ADDENDUM NO. 4

RE: ADA Improvements To
Hartley Job Administration Building
Project No. 11-0416

OWNER: Michigan City Port Authority
200 Heisman Harbor Drive
Michigan City, IN 46360

This Addendum is intended to clarify/revise the plans and specifications per the following items:

P1.1

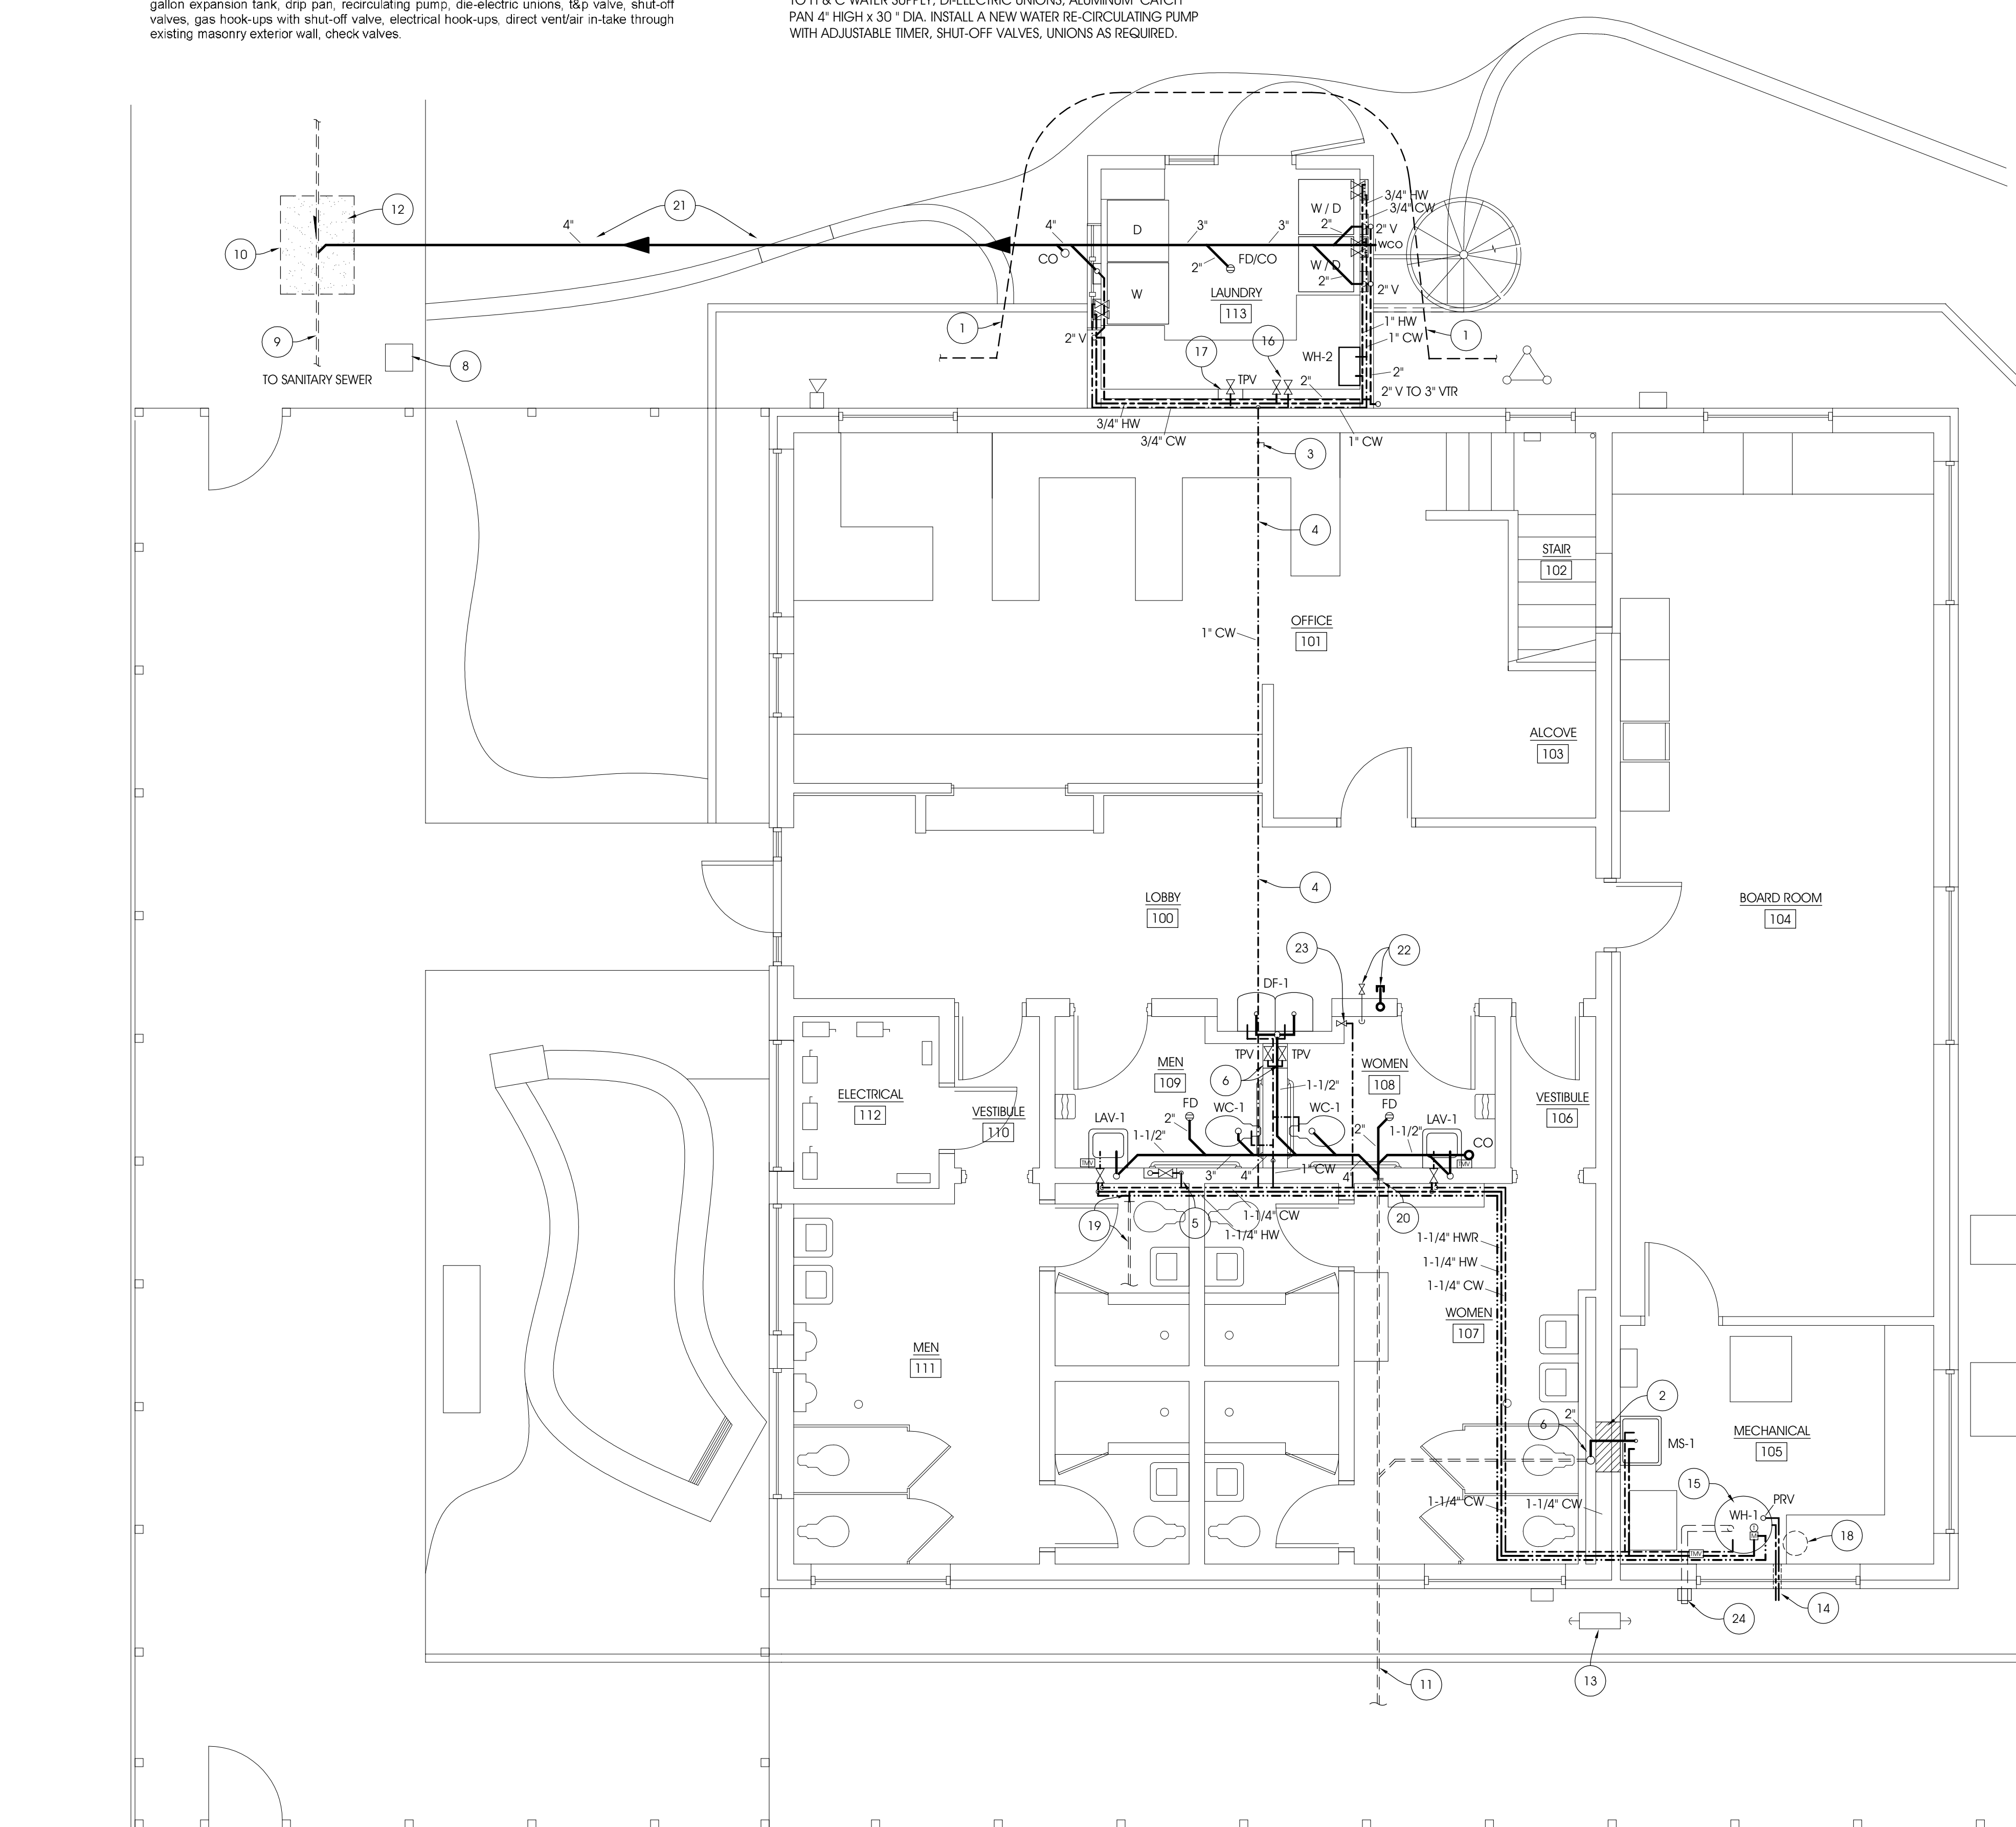
ITEM 2 SHEET P1.1 Addendum No. 2: Add keynotes 22, 23, and 24, Base Bid Note, adjust graphics from Addendum No. 3 including adding keynote changes.

22. CAP EXISTING WASTE PIPE AND CW SUPPLY LINE FLUSH WITH WALL FACE. COVER WITH S.S. COVER PLATE.
23. EXISTING CW SUPPLY LINE AND SHUT-OFF VALVE ABOVE EXISTING NEW SUSPENDED CEILING TO REMAIN.
24. CUT INTO EXISTING C.M.U. AND BRICK WALL AS REQUIRED TO INSTALL NEW EXHAUST / INTAKE VENT TO NEW WATER HEATER UNDER ALTERNATE NO. A-3. FLASH AND SEAL AROUND VENT AS REQUIRED.
